ENGINE - LP COMPRESSOR - INTRODUCE A REWORK PROCEDURE ON THE FAN FRAME ASSEMBLY -  
CATEGORY CODE 8 - MOD.ENG-72-0286

V2500-ENG-72-0286

Rework of the Fan Frame Assembly  
Fig.1

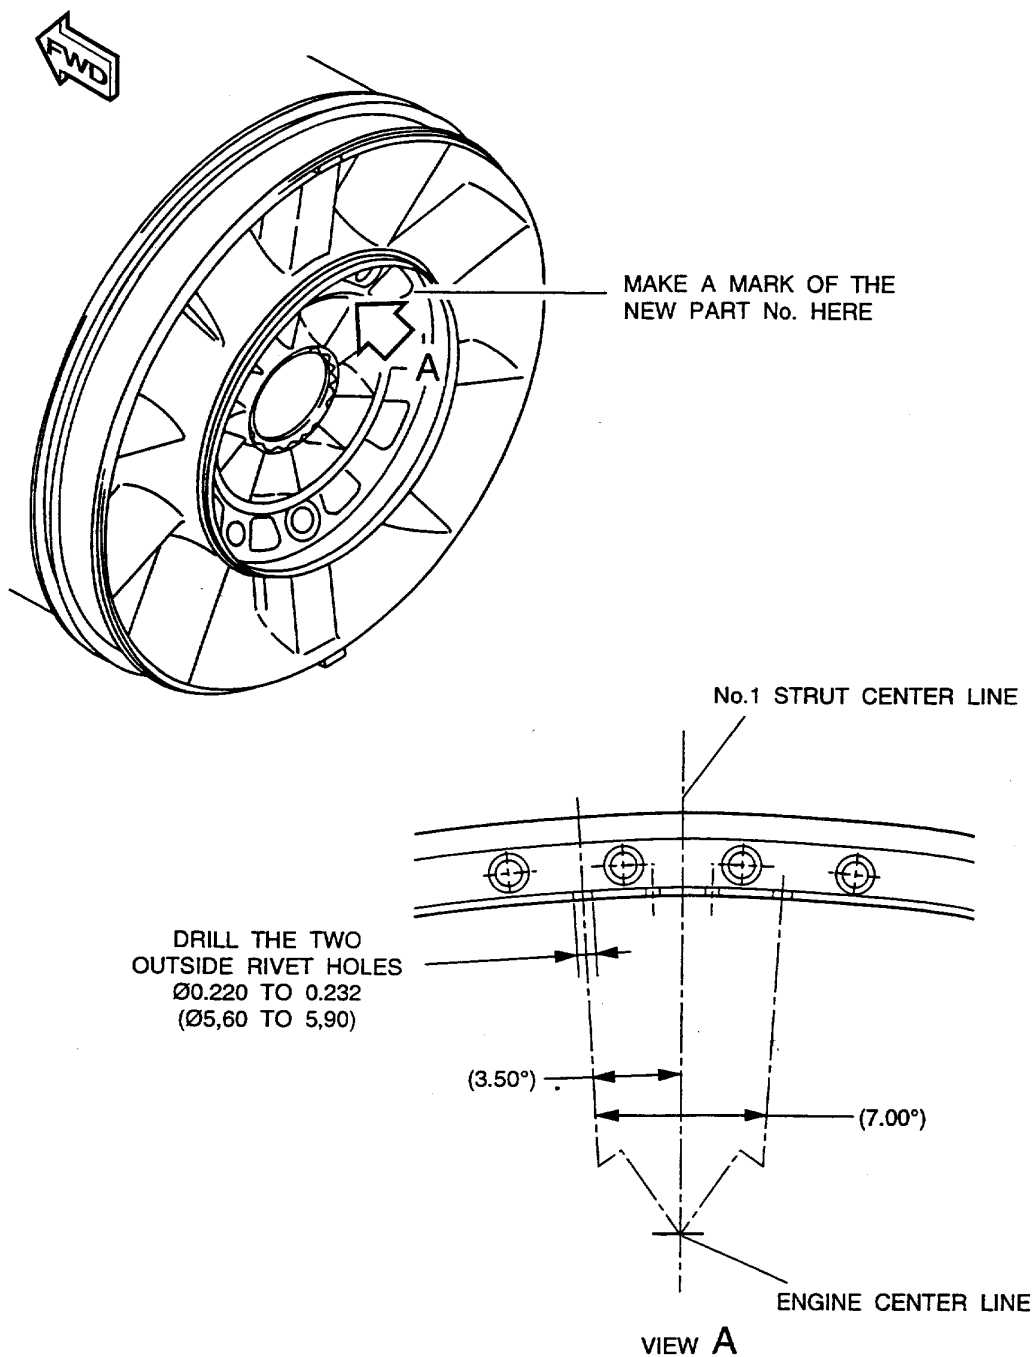
- (2) Rework procedure of fan frame is introduced to enlarge the current two rivet holes to bolt holes (See Figure 1).

- (b) Remove the existing rivets  
from the fan frame assembly
- (c) Remove the mount tube stopper
- (d) Make sure the drilling position  
on the fan frame assembly
- Refer to Figure 1

| (e) Make the diameter of the rivet hole larger at two positions (Outside of existing rivet holes)   | Refer to Figure 1,<br>Use a 0.220 to 0.232 in.<br>(5,60 to 5,90 mm.) drill |
| (j) Make a mark of the new part No. on the fan frame assembly adjacent to the old part No., make two lines (====) on the old part No. to erase it | Use the Vibro-Peen method, Refer to Figure 1 and A.(1), (a)                |

Install the mount tube stopper on the fan frame assembly  
Fig.2

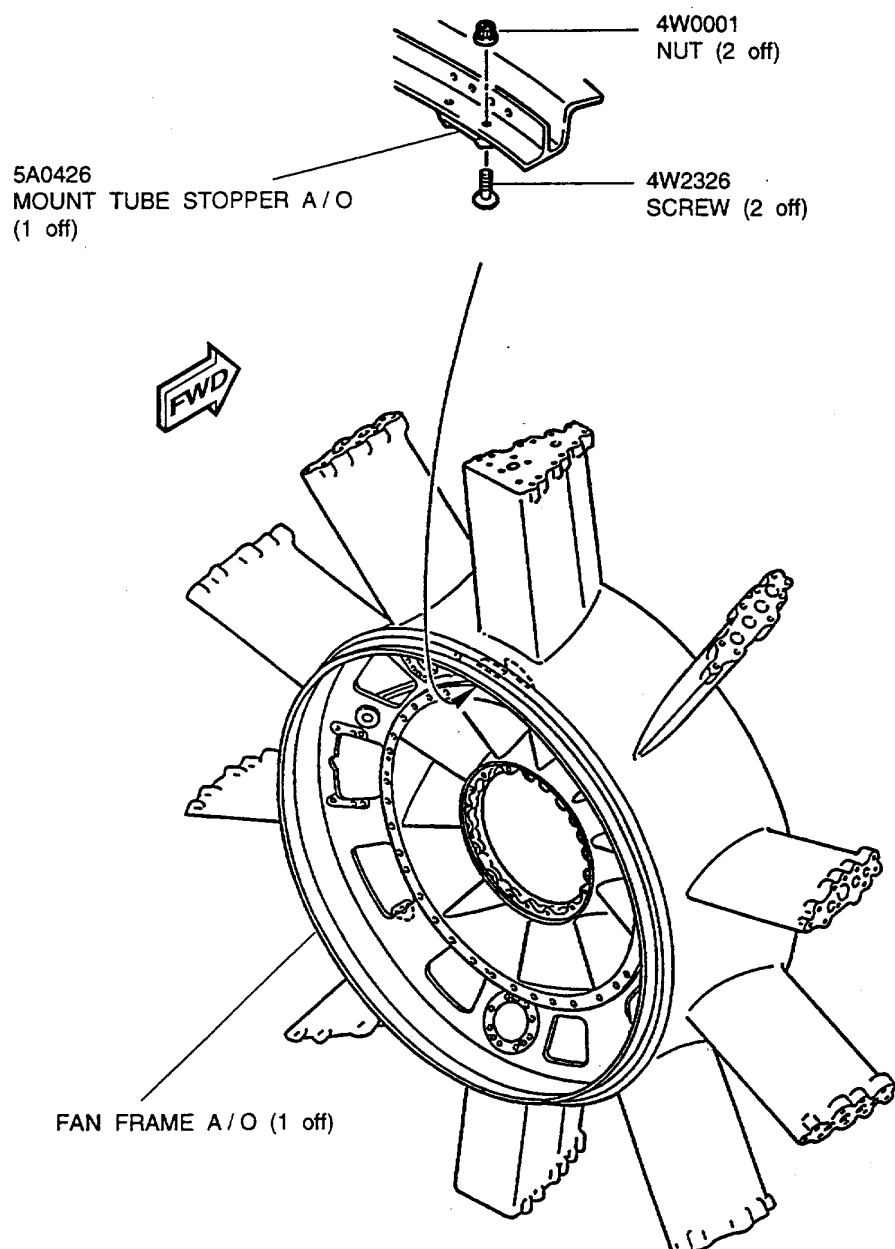
- (1) The new mount tube stopper which is secured by the bolts and nuts are introduced (See Figure 2).

- (1) Install the 5A0426, mount tube stopper to the fan frame assembly with the two 4W2326, screws and 4W0001, nuts. Refer to Figure 2.
